IN THE DRAWINGS:

Please replace the two (2) drawing sheets containing Figs. 1B and 1C and Figs. 6, 7, 9 and 14 with the "Replacement Sheets" included herewith. The corrections are shown in red ink on the two (2) sheets labeled "Annotated Marked-Up Drawings" also included, and reflect the following addition and modifications:

"ANNOTATED MARKED-UP DRAWINGS"

FIG. 1B

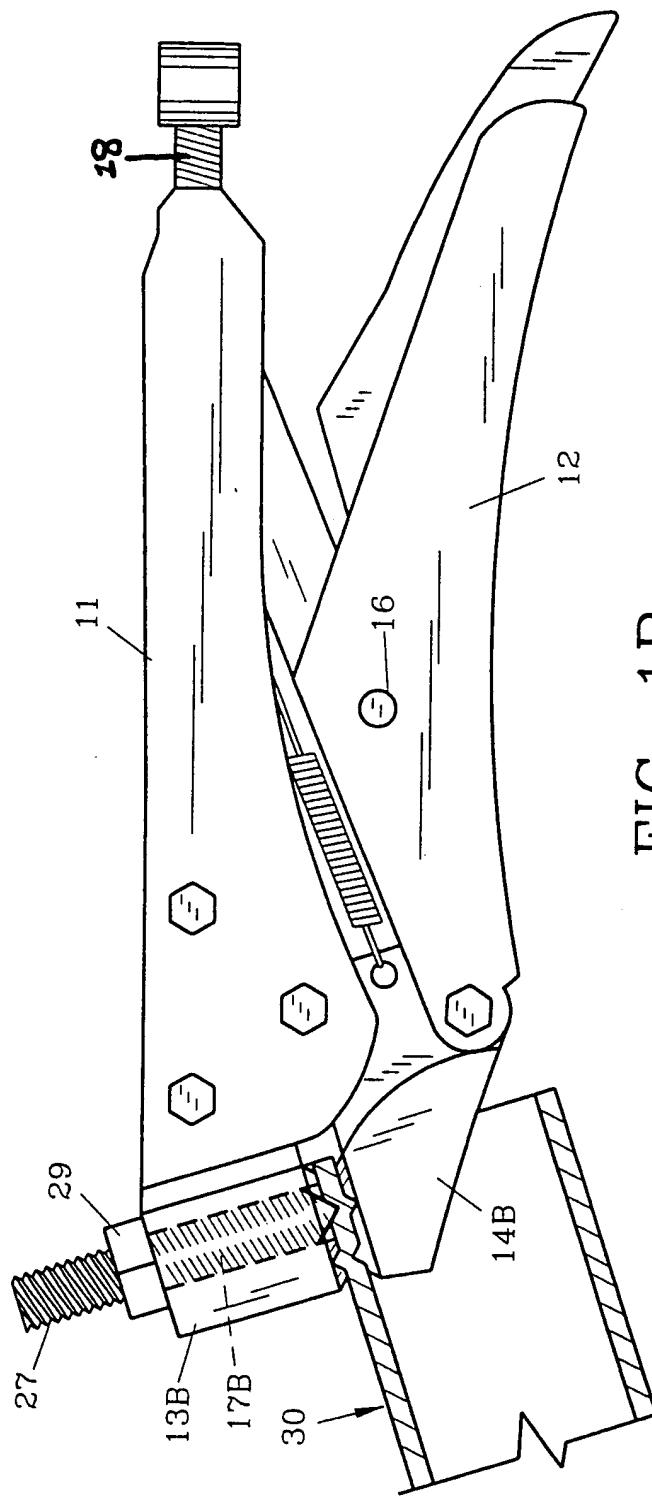
- 1) Numeral 18 in Fig. 1B to show threaded member 18;
- 2) In Fig. 7, numeral 39 has been changed to numeral 40, numeral 42 has been changed to numeral 39 and numerals 36 and 41 with their respective directional lines and arrows have been removed.
